I Redline Revision Dated April 18, 2011

US 50 (OCEAN GATEWAY) AT OCEAN LANDING EAST ENTRANCE

BERLIN, MARYLAND

TRAFFIC SIGNAL PLAN

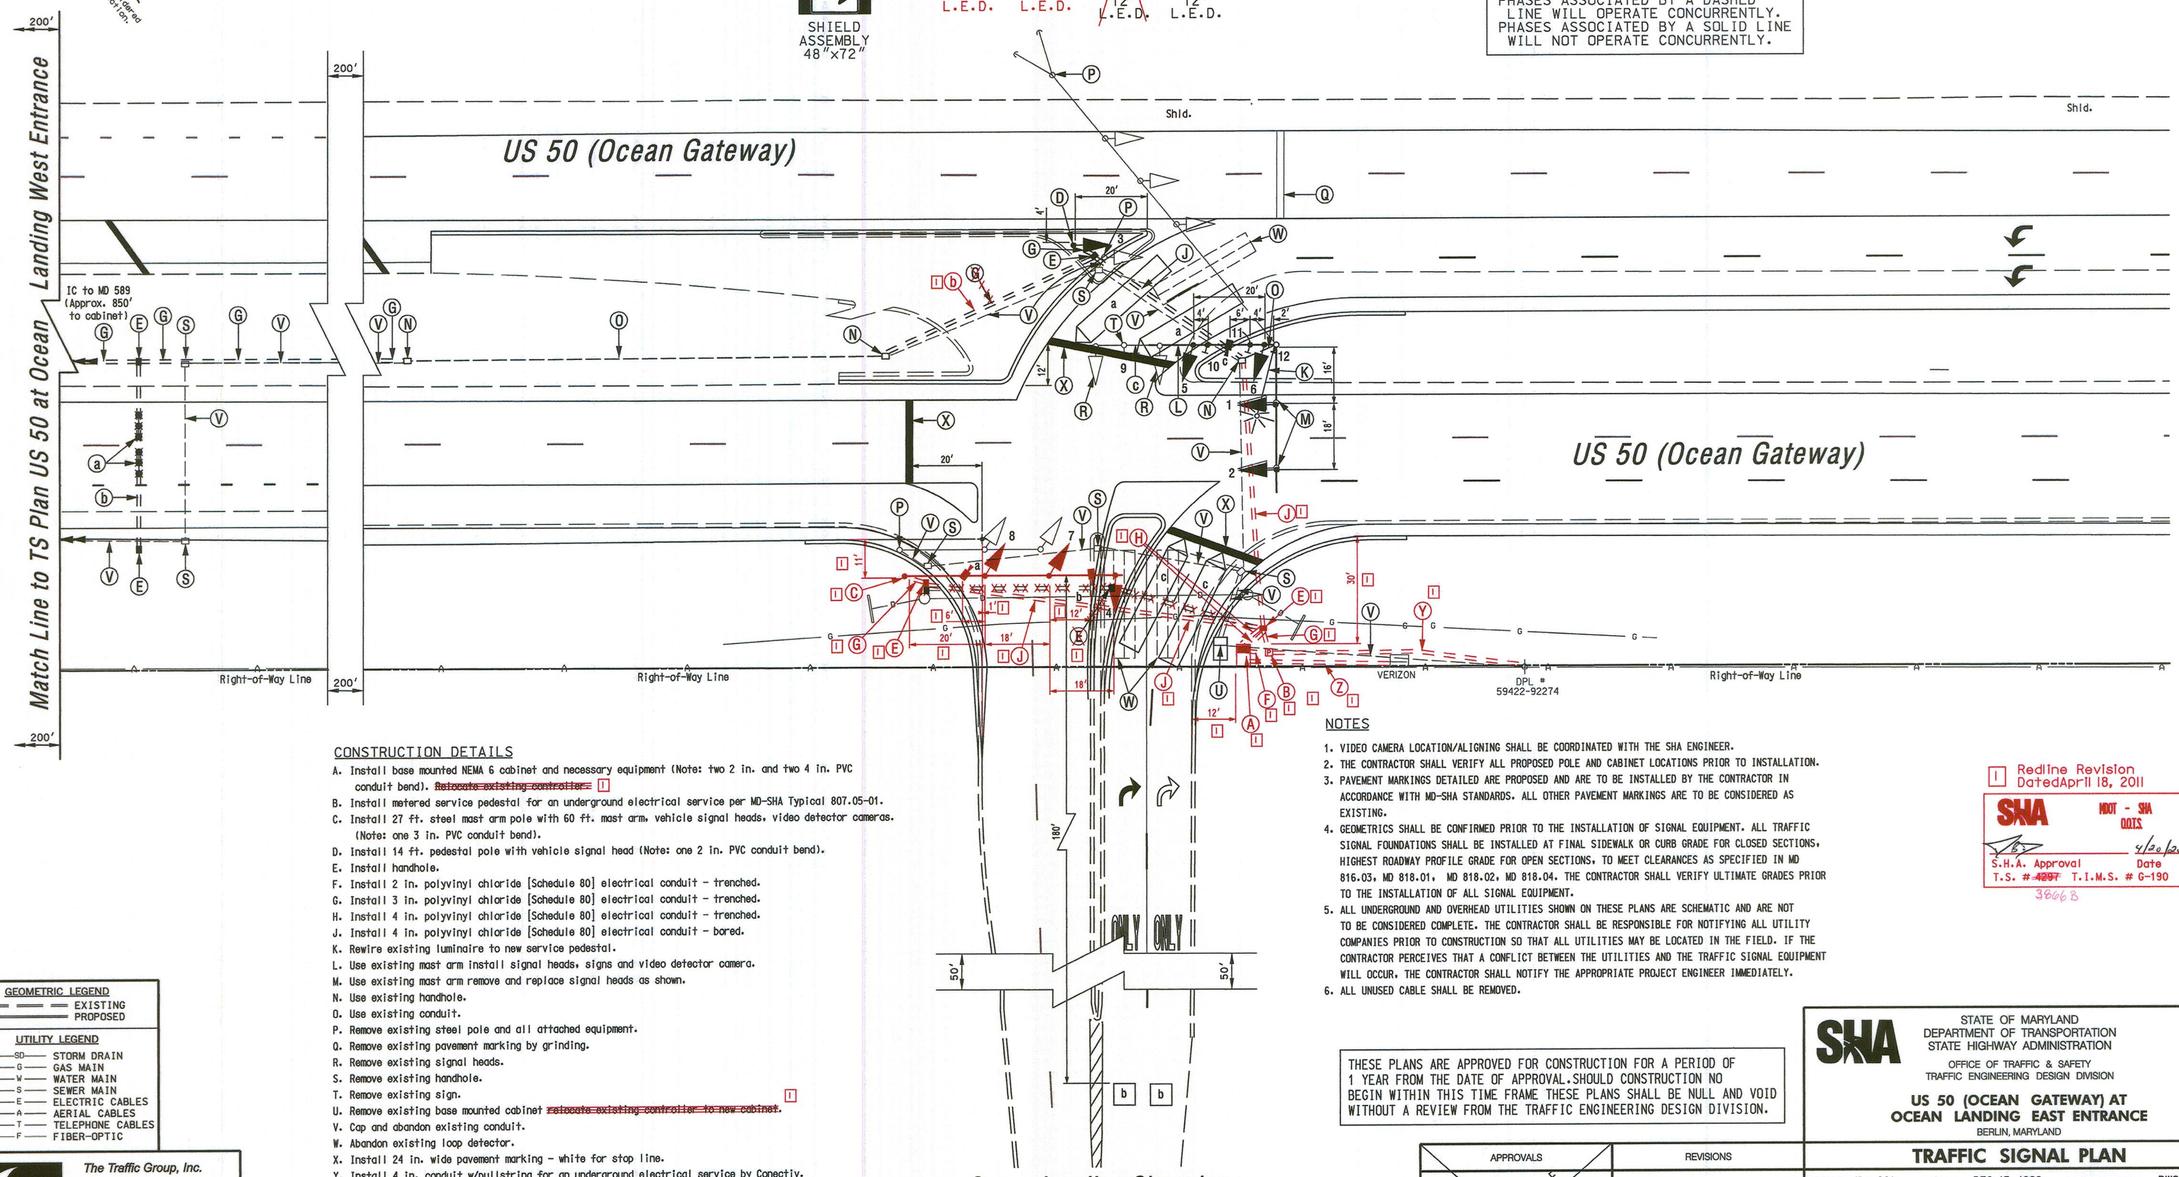
~~4~~ I — R, Y, G — 12" L.E.D.

1,2,~~4~~ 4,7,8 I — R, Y, G — 12" L.E.D.

A. Install base mounted NEMA 6 cabinet and necessary equipment (Note: two 2 in. and two 4 in. PVC conduit bend). ~~Relocate existing controller.~~ I
B. Install metered service pedestal for an underground electrical service per MD-SHA Typical 807.05-01.

R. Remove existing signal heads.
S. Remove existing handhole.
T. Remove existing sign. I
U. Remove existing base mounted cabinet ~~relocate existing controller to new cabinet~~.
